11 SUB2008-00223

ISLAND ROAD SUBDIVISION

ISLAND ROAD SUBDIVISION

APPLICATION NUMBER _____11 ___ DATE November 6, 2008 NTS

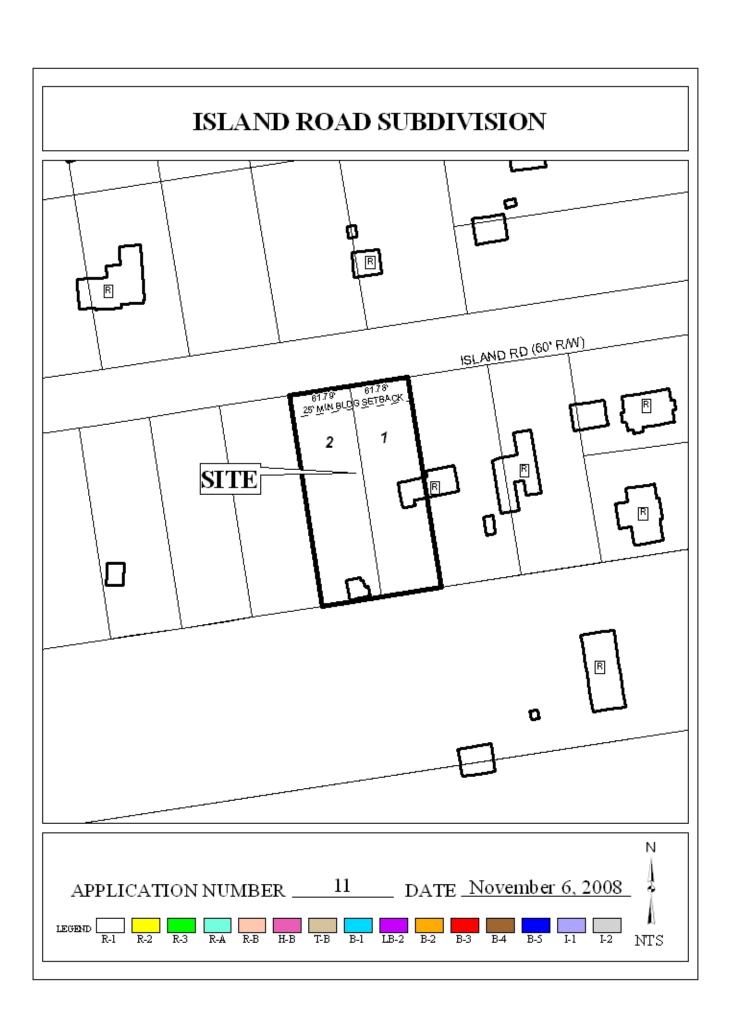
The site fronts on Island Road, a minor street with adequate 60' right-of-way. As a means of access management, a note should be required on the final plat stating that each lot is limited to one curb cut to Island Road, with the size, location and design to be approved by County Engineering and conform to AASHTO standards.

The plat indicates the 25' minimum building setback line along Island Road and this should also be shown on the final plat. The lots are not labeled with their sizes; therefore, the plat should be revised to label each lot with its size in square feet and acres, or a table should be furnished on the plat providing the same information.

According to Section V.D.3 of the Subdivision Regulations, the maximum depth of any lots shall not be more than 3.5 times the width of the lot at the building setback line. While the proposed lots will slightly exceed this ratio, long, narrow lots are common to the area and a waiver of Section V.D.3. would be required and appropriate.

While the site is in Mobile County, it will have to comply with the City of Mobile storm water and flood control ordinances. A note should be placed on the final plat stating that the development will be designed to comply with the storm water detention and drainage facility requirements of the City of Mobile storm water and flood control ordinances, and requiring # 11 SUB2008-00223

A note should be placed on the Final Plat stating that any lots which are developed commercially and adjoin residentially developed property must provide a buffer, in compliance with Section V.A.7. of the Subdivision Regulations.

With a waiver of Section V.D.3., the proposed plat meets the minimum requirements of the Subdivision Regulations and is recommended for tentative approval subject to the following conditions:

- 1) placement of a note on the final plat stating that each lot is limited to one curb cut to Island Road, with the size, location and design to be approved by County Engineering and conform to AASHTO standards;

- 2) illustration of the 25' minimum building setback line along Island Road;
- 3) labeling of each lot with its size in square feet and acres, or the furnishing of a table on the final plat providing the same information;

- 4) placement of a note on the final plat stating that the development will be designed to comply with the storm water detention and drainage facility requirements of the City of Mobile storm water and flood control ordinances, and requiring submission of certification from a licensed engineer certifying that the design complies with the storm water detention and drainage facility requirements of the City of Mobile storm water and flood control ordinances prior to the issuance of any permits. Certification is to be submitted to the Planning Section of Urban Development and County Engineering;

- 5) placement of a note on the final plat stating that development of the site must be undertaken in compliance with all local, state and Federal regulations regarding endangered, threatened or otherwise protected species; and

- 6) placement of a note on the final plat stating that any lots which are developed commercially and adjoin residentially developed property must provide a buffer, in compliance with Section V.A.7. of the Subdivision Regulations.
